## DOCUMENT CHANGE NOTICE (DCN)

DOCUMENT No. (DOC-REV-GP. ID)	TITLE	NEW REV.
D970551-D-D	Recycling Mirror LOS Structure Assembly	E
D960503-A-D	LOS Top Plate	B
D960505-A-D	LOS Bottom Plate	B
D960145-B-D	LOS Height Adapter Assembly	C

**D970551:** Incorporate attached DCN for revision D.

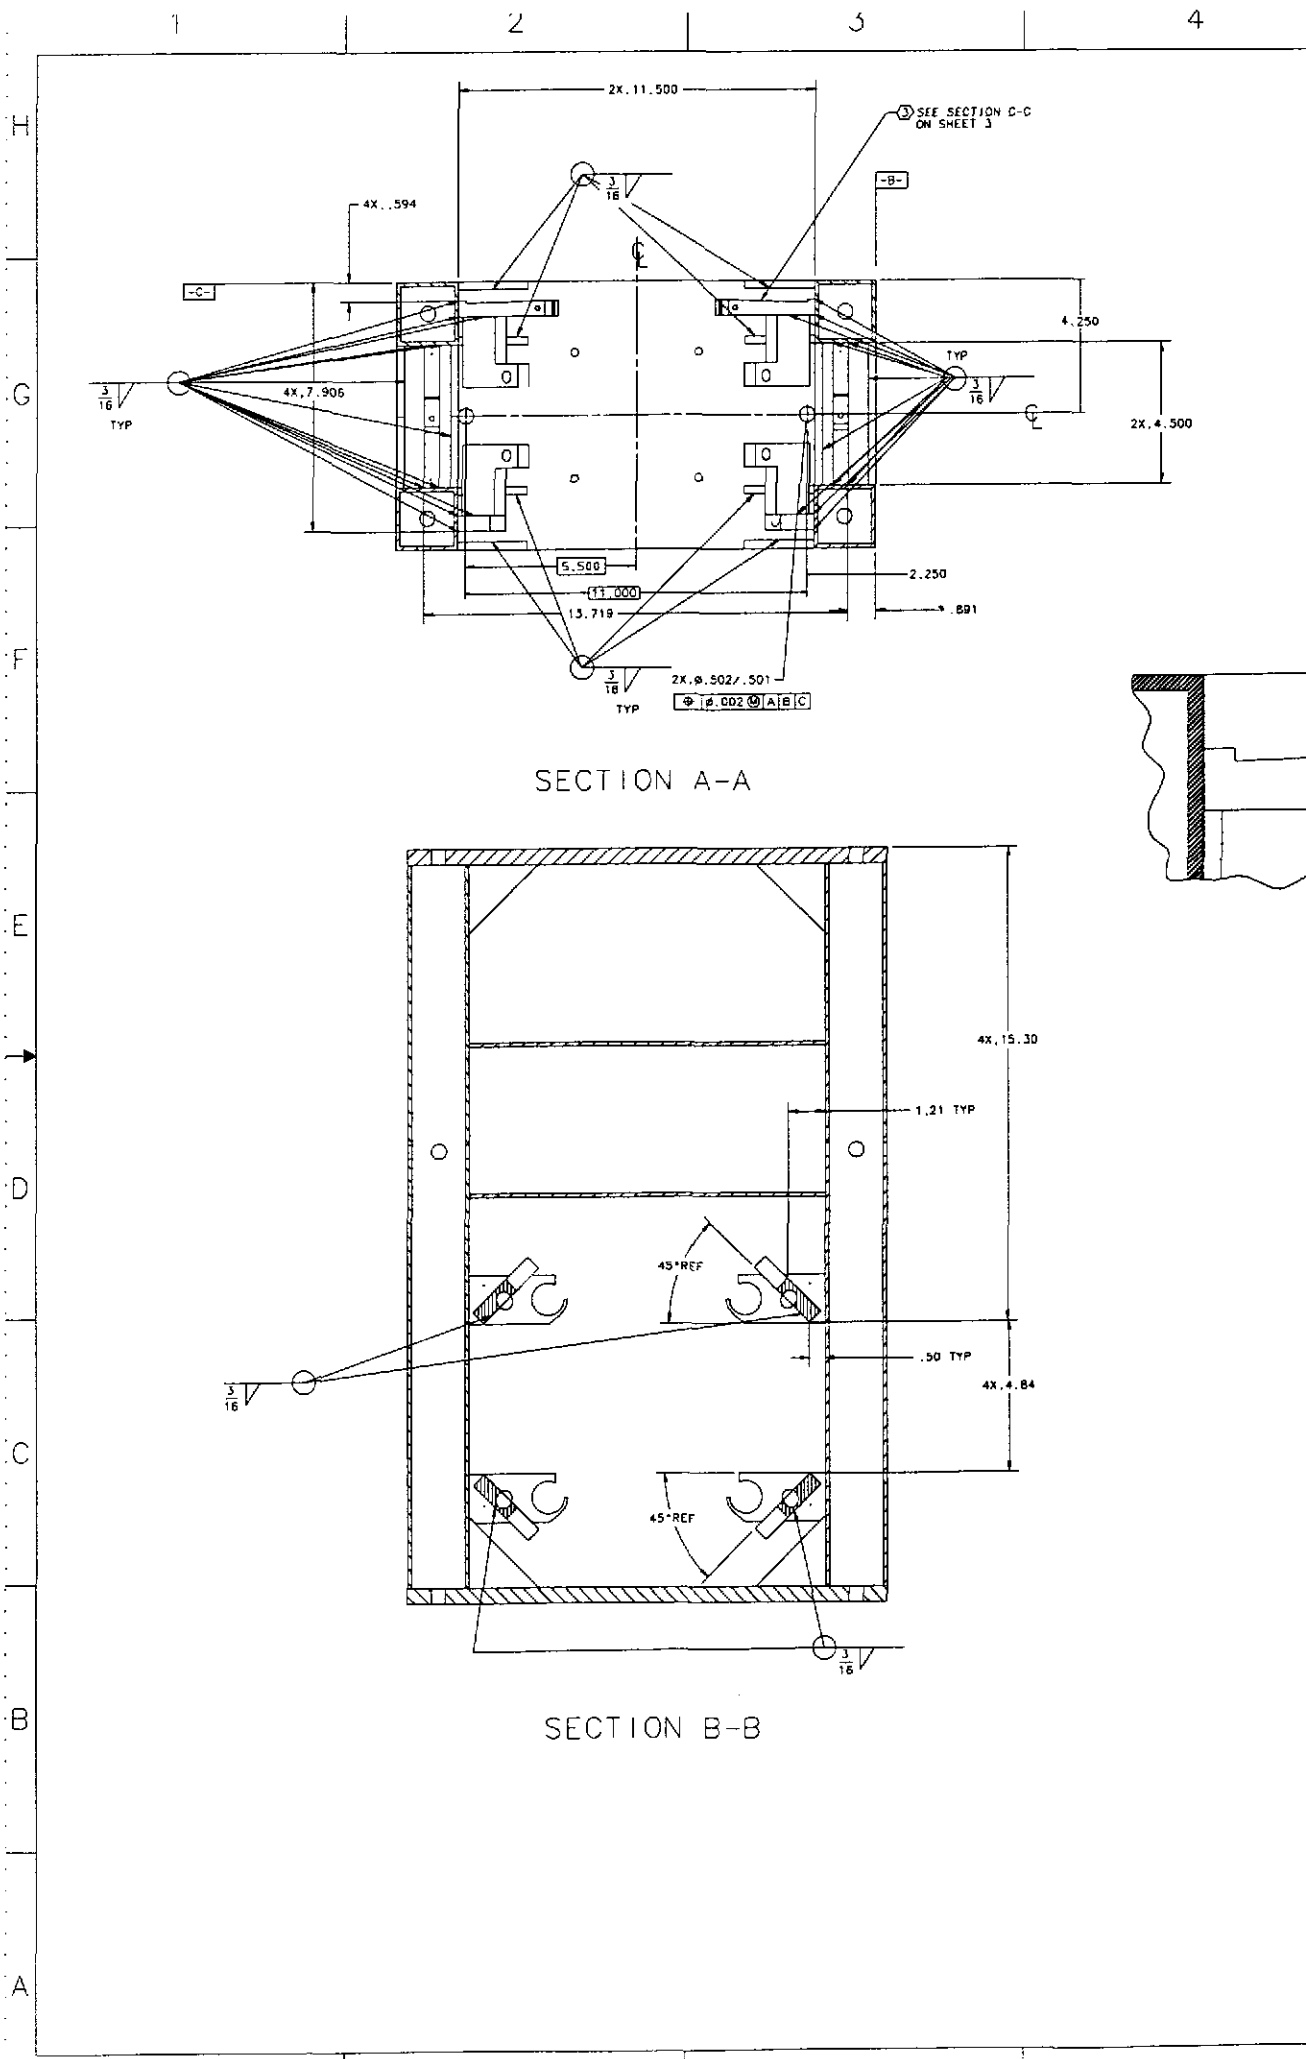
Chamfer stop angles needed to be revised to allow for input into an NC machine program. Add sheets 5 and 6. Remove Table 1. See revision C for "was" condition. Add dimension to control overall height.

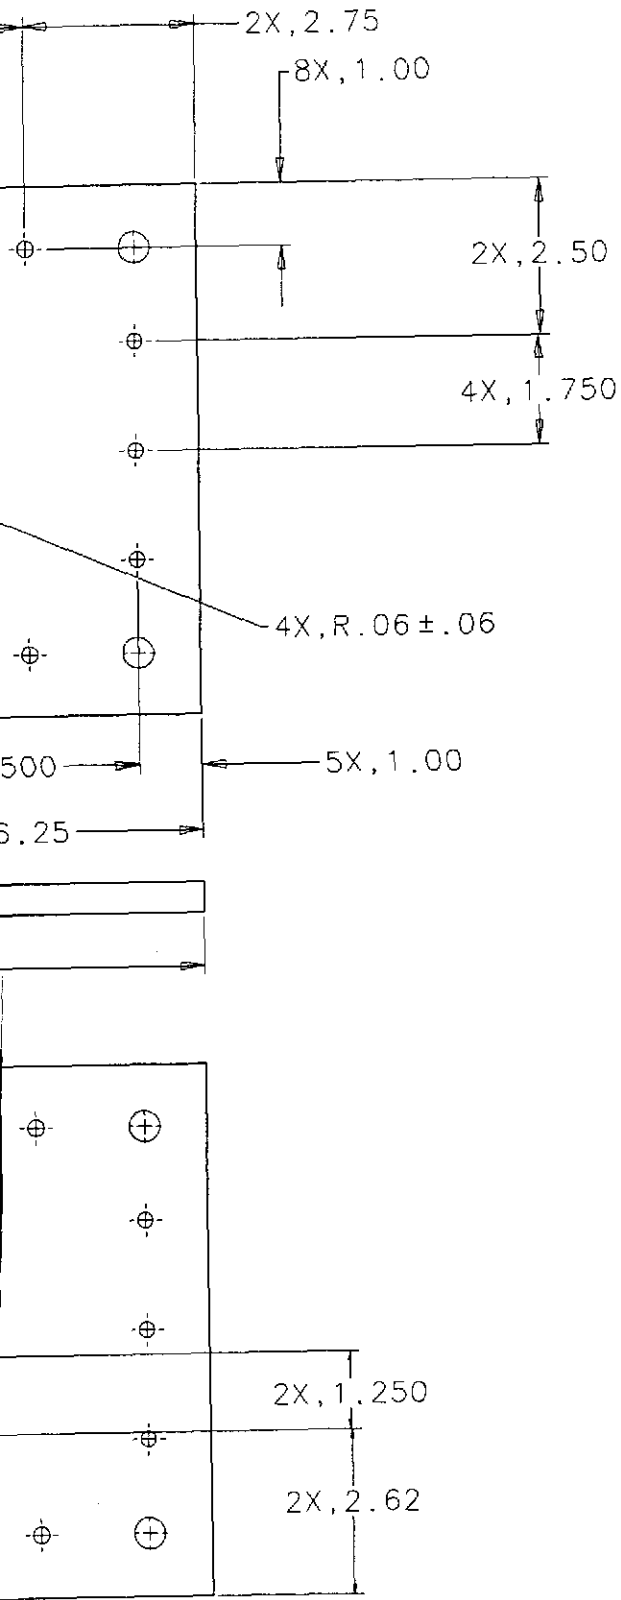
**D960503:** Change holes dimension from .50" from the edges to 1.00 from the edges.

PART NAME		DESCRIPTION		DATE	
D960133, D970551		304 STAINLESS		4/98	
FILE LOCATION /home/dcc/bdes/D960505.pdf		MATERIAL 304 STAINLESS		DATE 4/98	
		FINISH NONE		TITLE LOS BOTTOM PLATE	
				PARTS LIST D960505	
				SCALE 1:1	
				SHEET 1 OF 1

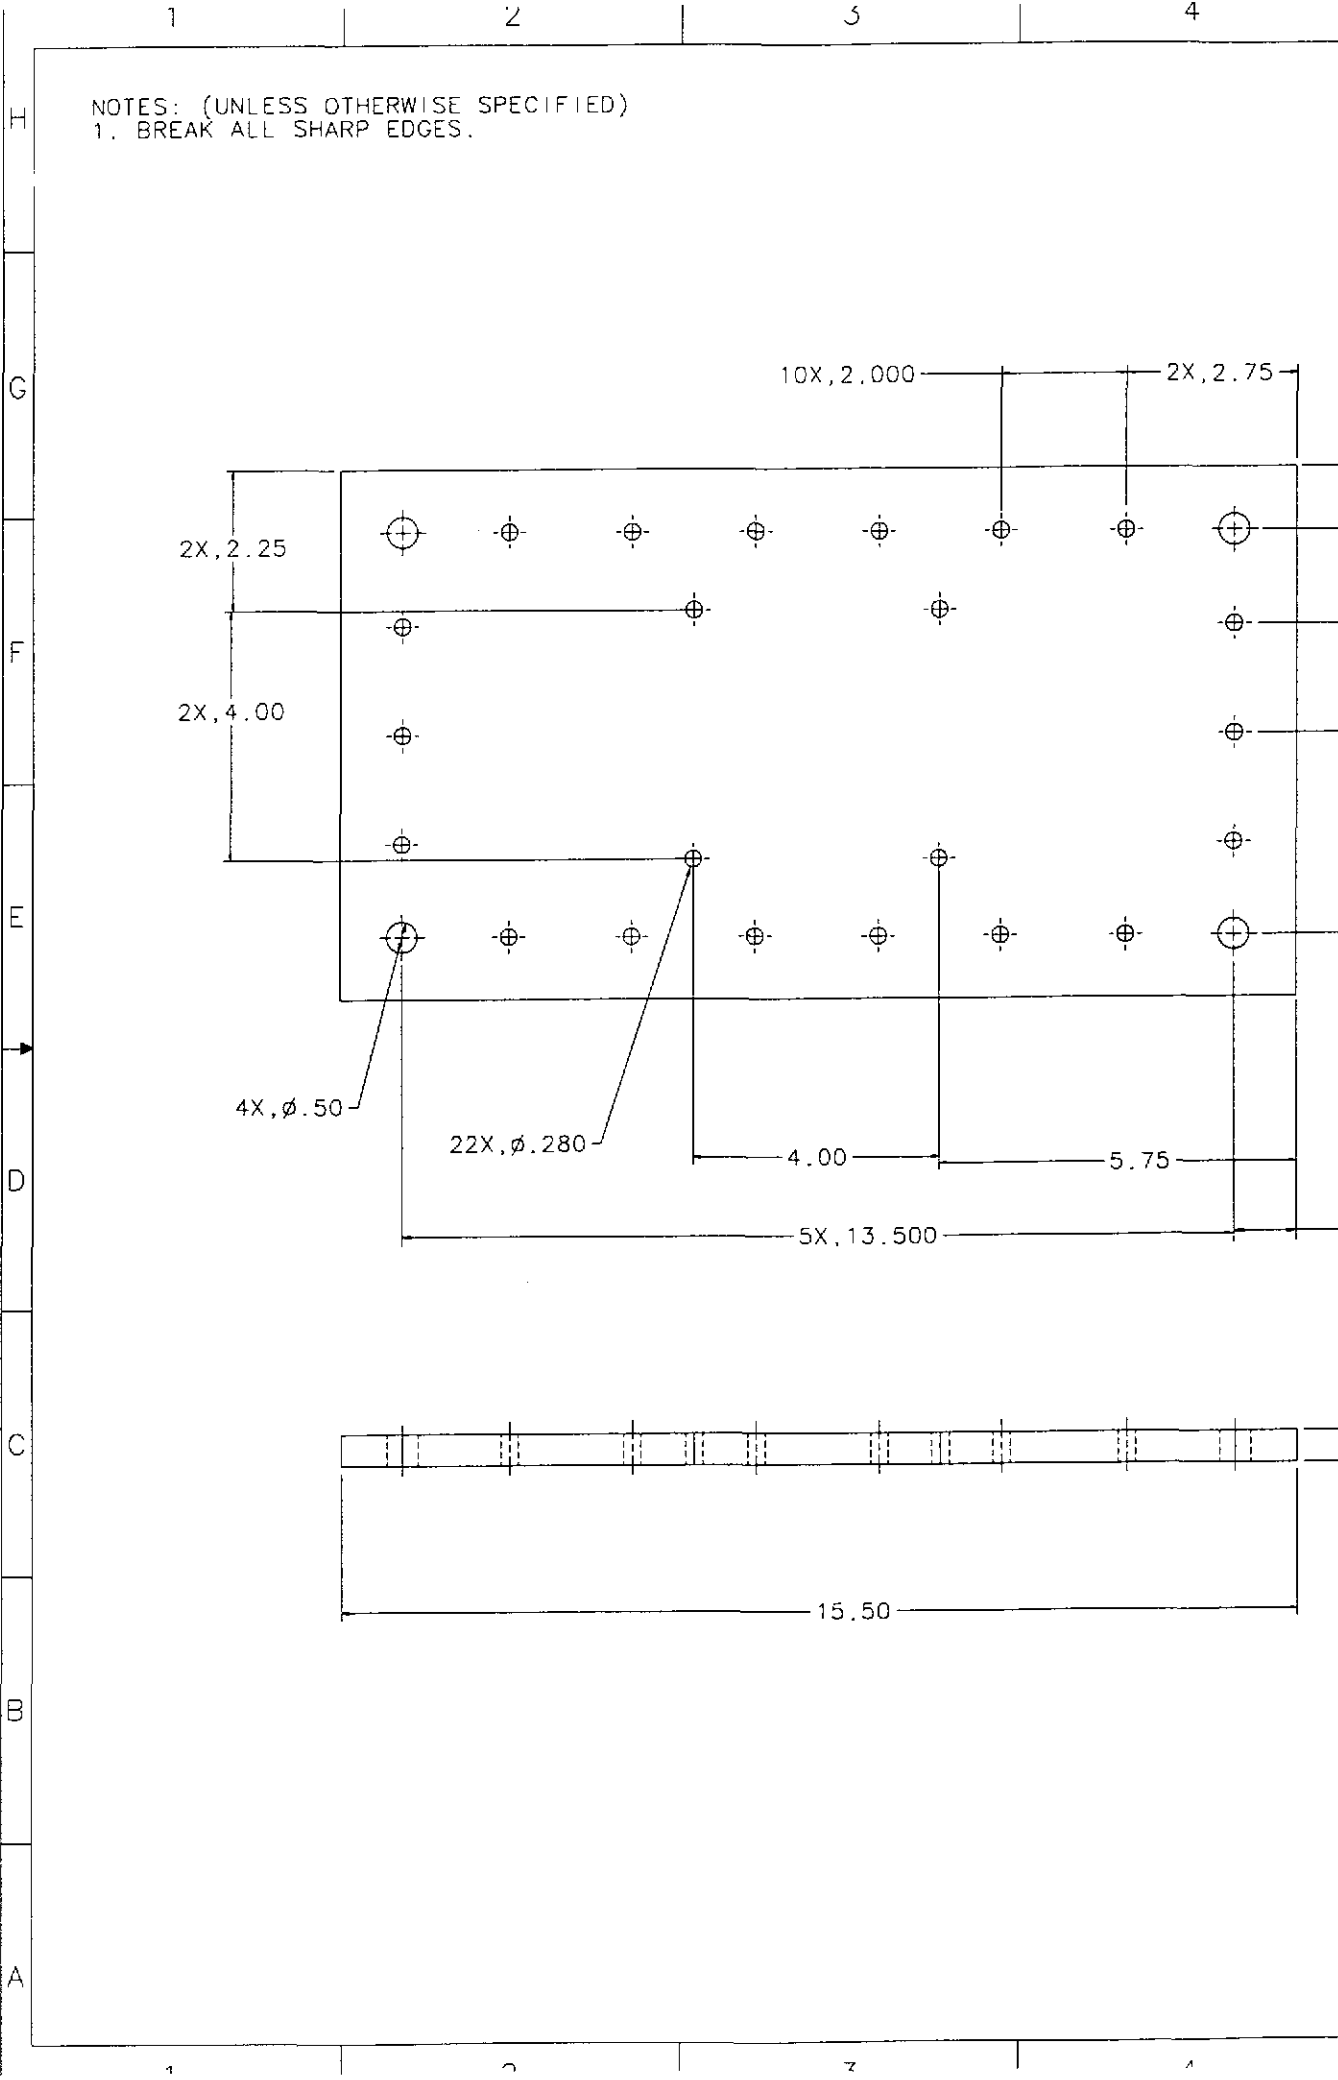
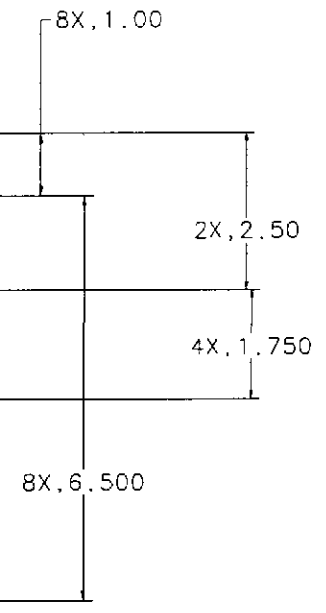
**D960505:** Change holes dimension from .50" from the edges to 1.00 from the edges.

MATERIAL	304 STAINLESS	REV	C
FILE LOCATION	home/dcc/docs/D960145.ppt	REV	C
SEE NOTES		MAX 1/2	SHEET 1 OF 1

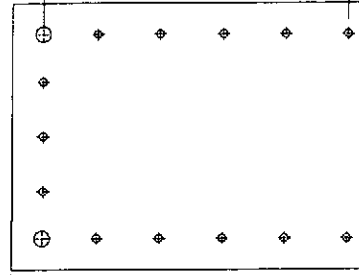
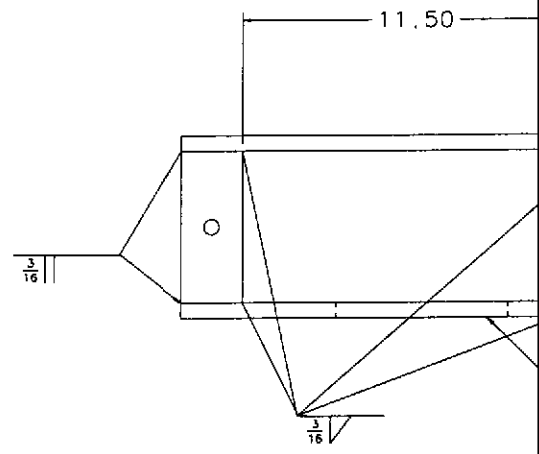
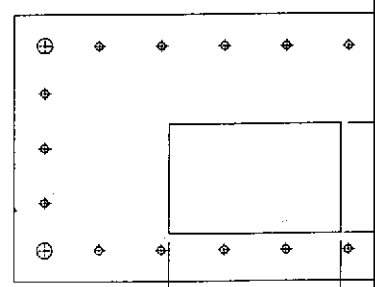
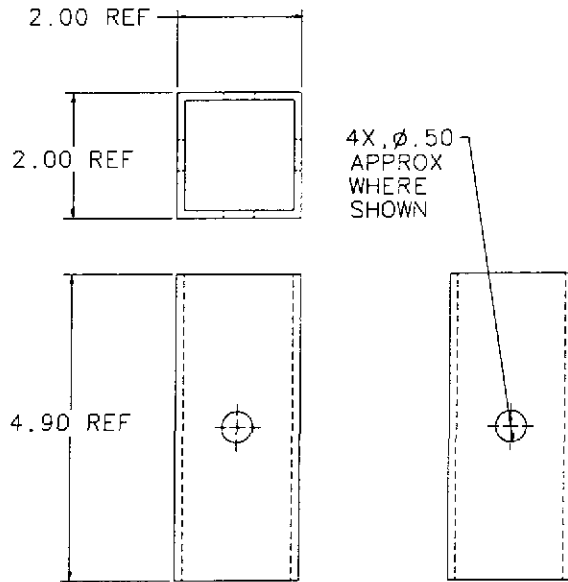
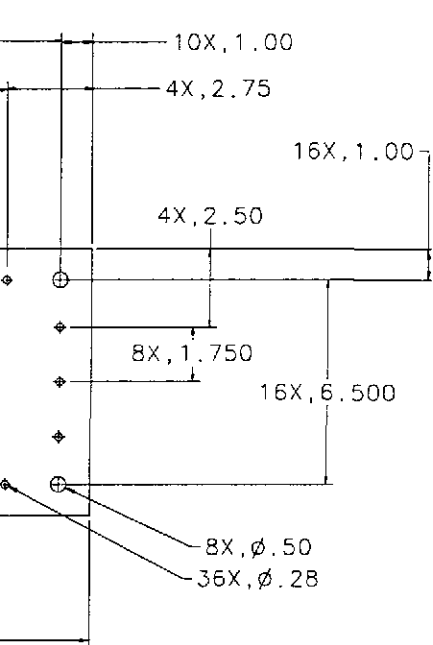
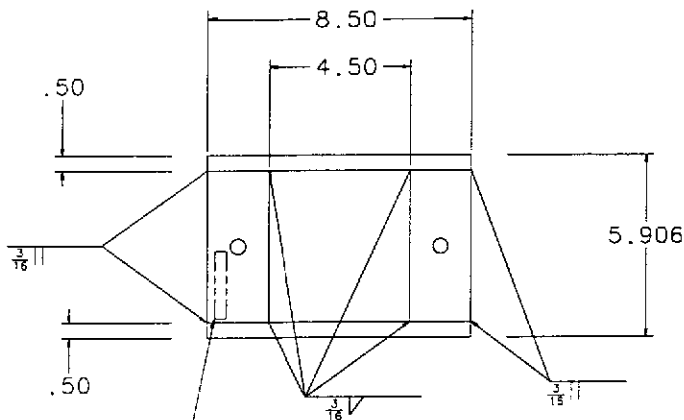
**D960145:** Incorporate attached DCN for revision B. Change holes dimensions from .50" from the edges to 1.00 from the edges. For the rectangular hole, change 1.00 dimension to 1.50 to the edge.
